# **Harestanes South Windfarm Extension**

## **Environmental Impact Assessment Report Addendum**

### **Appendix A2 – Consultation with ECU (Ironside Farrar)**

### STAGE 1 CHECKING REPORT

SI Figure 6.1.13: Receptors

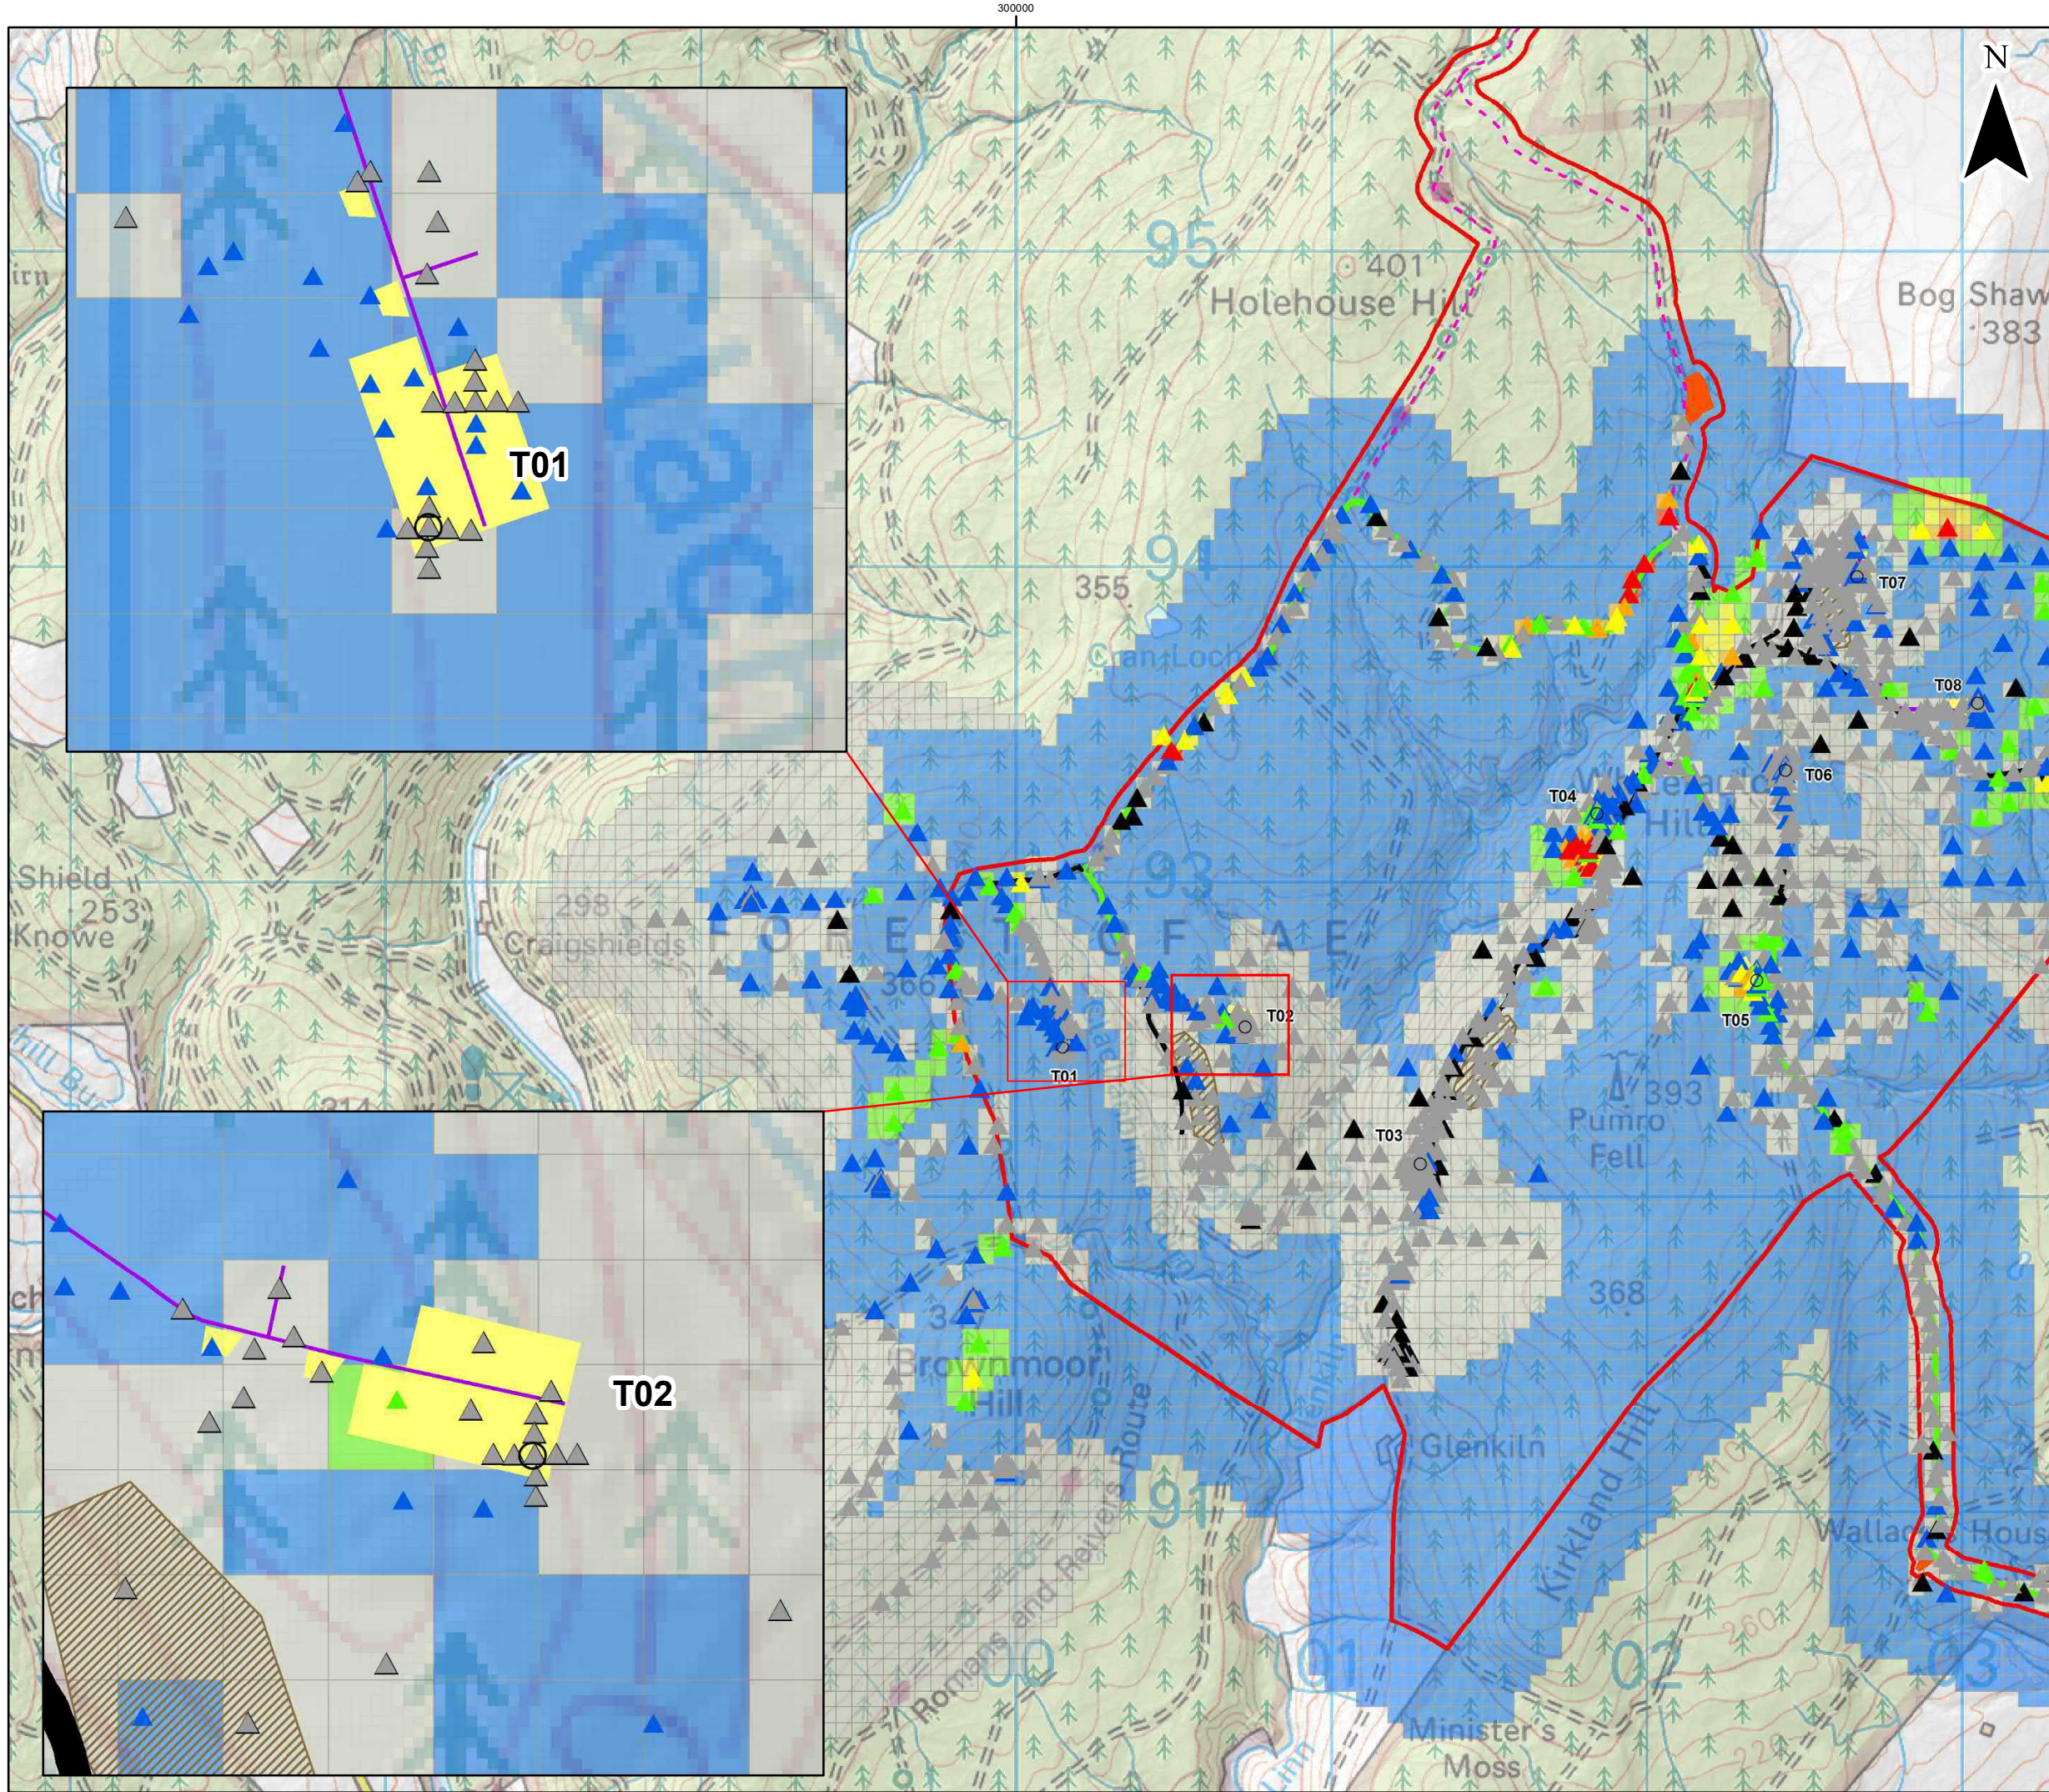
A figure showing all the receptors that are present within the site and within influence beyond the site would have been useful for the reader and would add to the assessment.

*Ironside Farrar noted that 'Table 6.9 does not appear to consider receptors over 100m from each cell where consequence is calculated. It is known that peat slides can travel over distances greater than this, and it is therefore unclear how this has been taken into consideration in calculating consequence across the site'.*

The assessment extends at least 250m beyond the Application Boundary, with the majority of infrastructure well within the Application Boundary.

WSP recognises the value identified of the additional recommendation to provide a supplementary figure showing all receptors considered within the Consequence assessment, this has been presented as the enclosed SI Figure 6.1.13 Receptors.

SI Figure 6.5a: Peat Detail (Western)

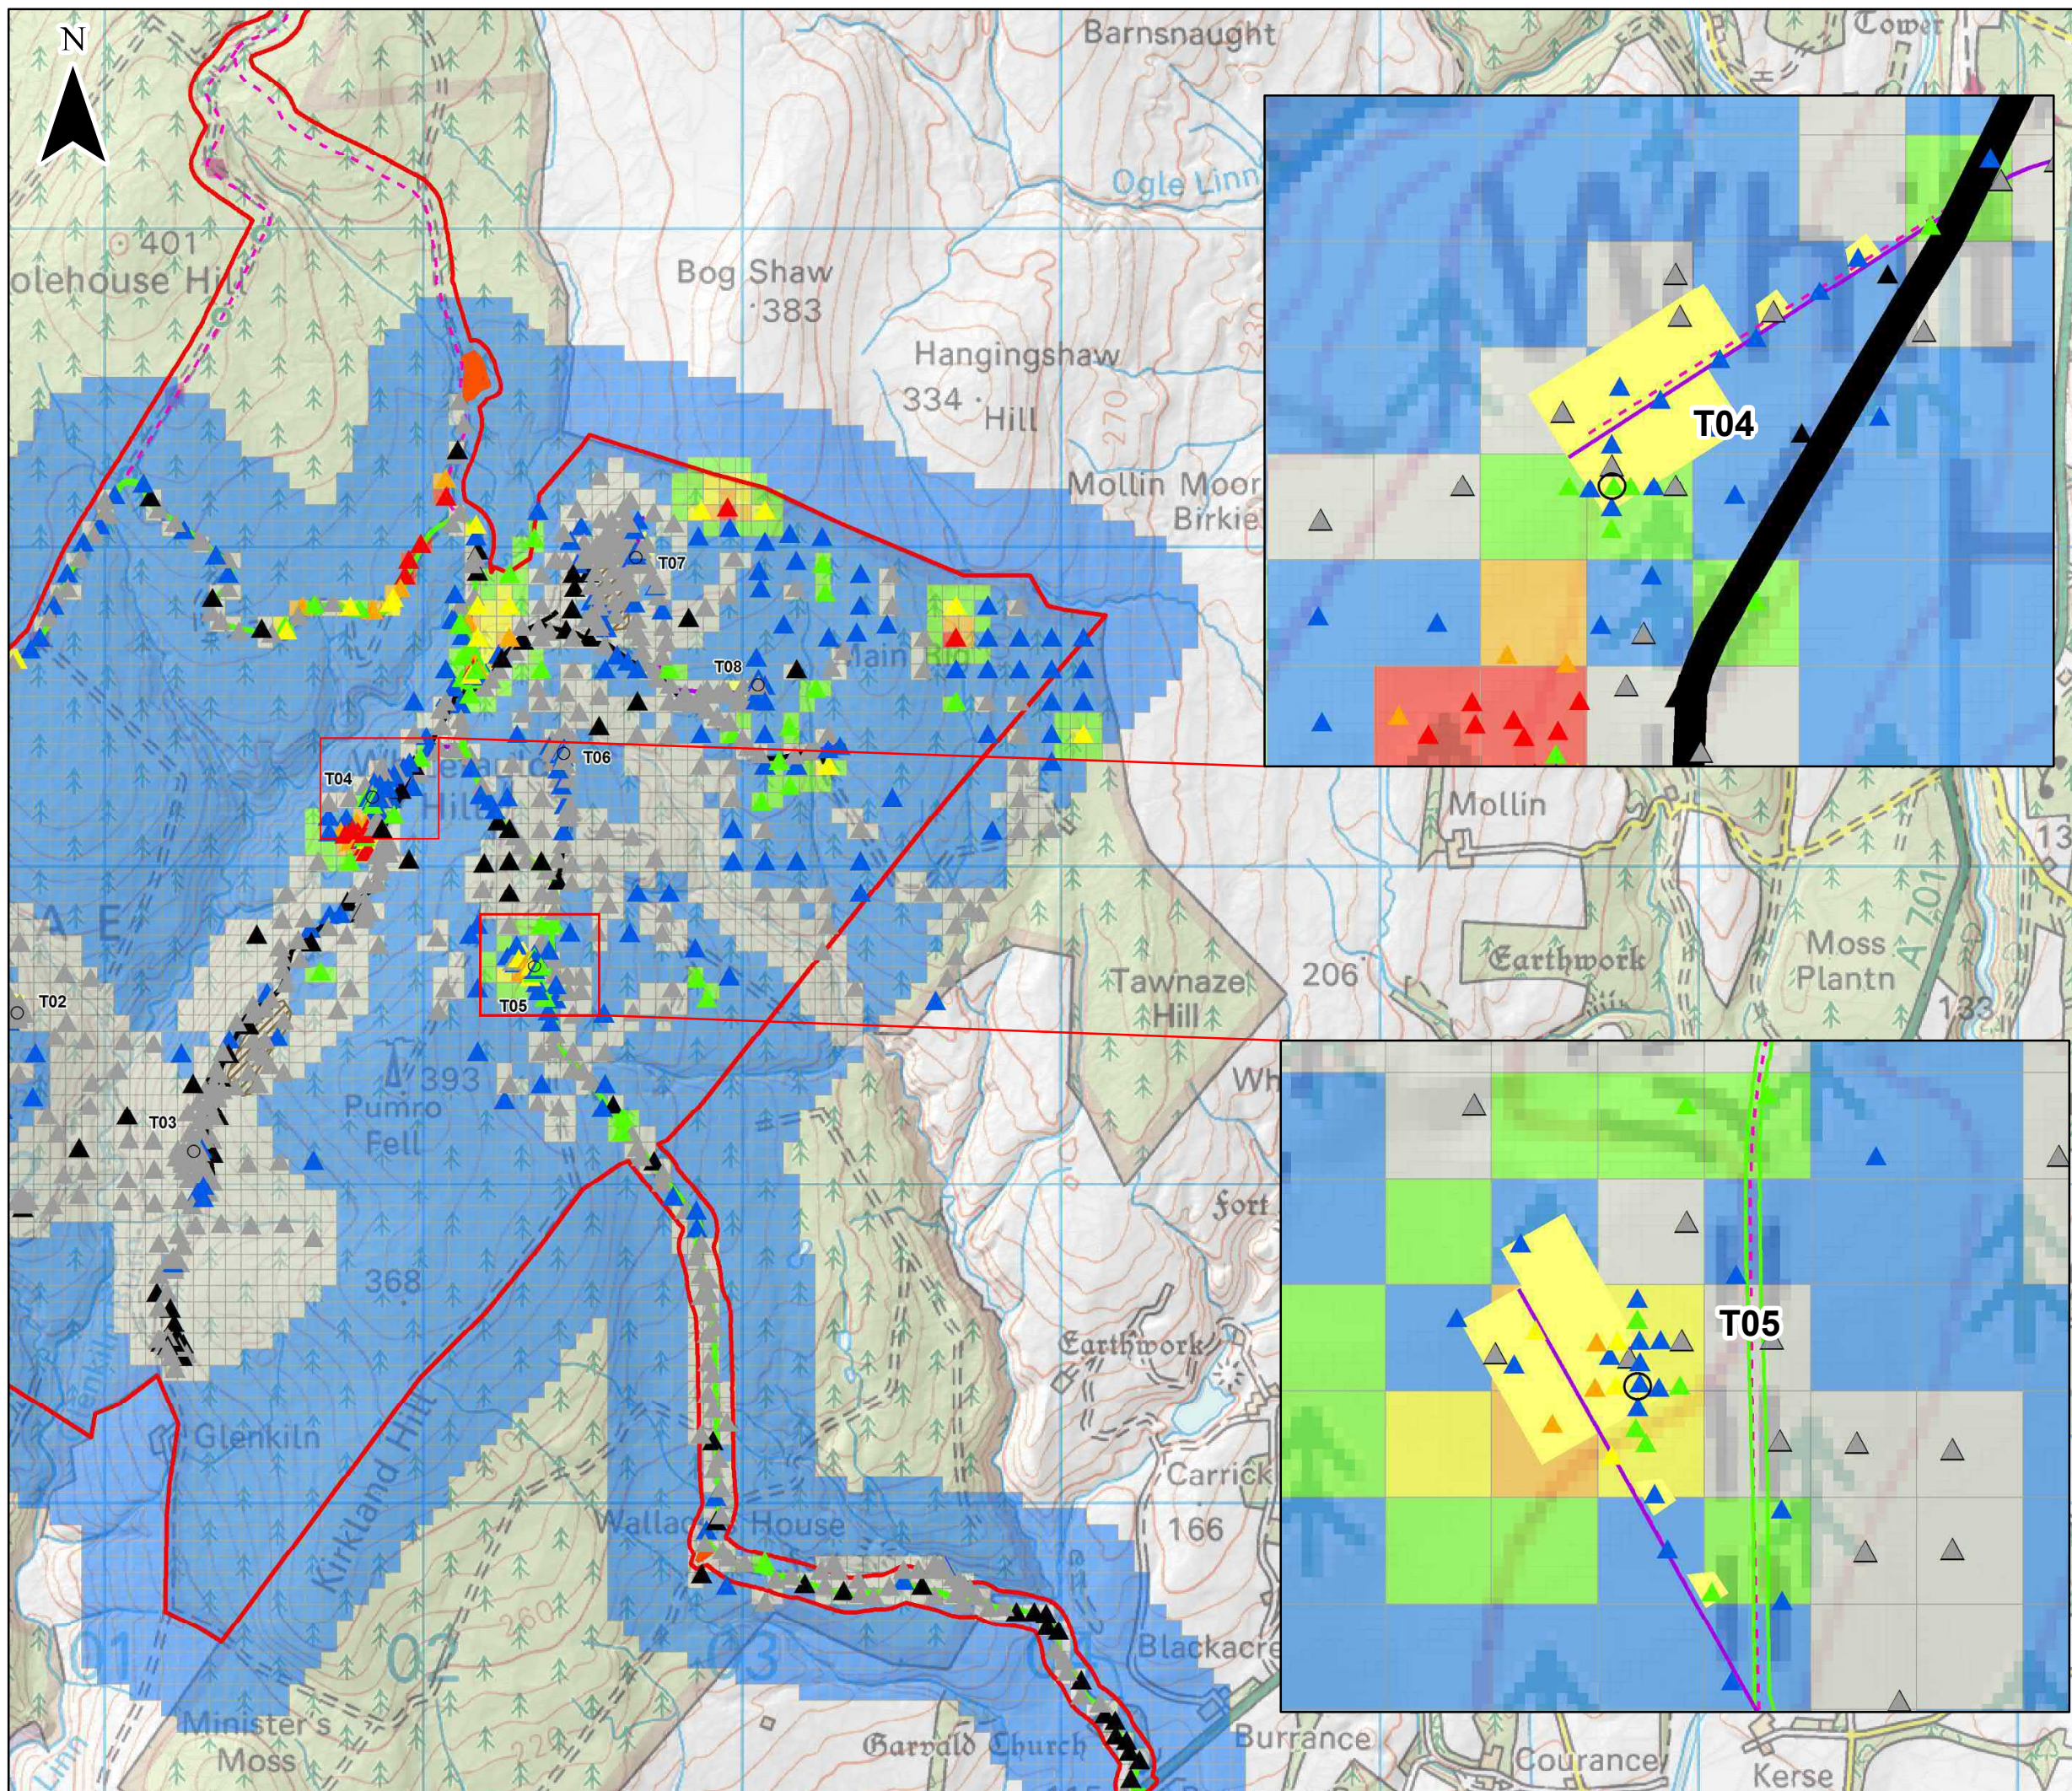
- Details are required on the probing density adopted for all infrastructure including turbines and how this aligns with the SEPA/ ECUBPG.
- The lack of a Phase I site wide peat probing survey is a significant short coming in the report, and a deviation from the ECUBPG. Clarification is required as to whether the lack of site wide probing has affected the robustness of the assessment. It is not clear how the peat depths presented on large parts of the peat depth mapping have been generated without probe information. This has raised some concern as to whether the peat depths presented on the mapping are sufficiently supported by site data and in turn are sufficiently representative of the overall picture of peat on the site. This inevitably has the potential to affect the risk assessment and its outcomes. Whilst it is appreciated that some of these areas will not be in influence of the proposed infrastructure, it is ensuring that areas that are within influence, have been adequately assessed, e.g. upslope and downslope locations of wind turbines, tracks etc.

*Details are required on the probing density adopted for all infrastructure including turbines and how this aligns with the SEPA/ ECUBPG.*

*Ironside Farrar requested 'further explanation is required as to how peat depths have been arrived in areas of the site that do not contain any specific peat depth data and whether the depths presented on the mapping are therefore accurate and sufficiently representative to take through the risk assessment'.*

The enclosed Peat Overview and Detail SI Figures 6.5 a – d show the probing density within the Proposed Development.

A presentation error on the EIA Report Peat Overview and Detail Figures was noted, the peat depths surveys results were shown as an interpolated map (using Simple Krigging method) rather than a 50 m grid, as explained in Technical Appendix 6.1. This error does not alter the assessment results; however, it has been amended on the enclosed Peat Overview and Detail SI Figures 6.5 a – d to be consistent with the methodology explained in Technical Appendix 6.1.
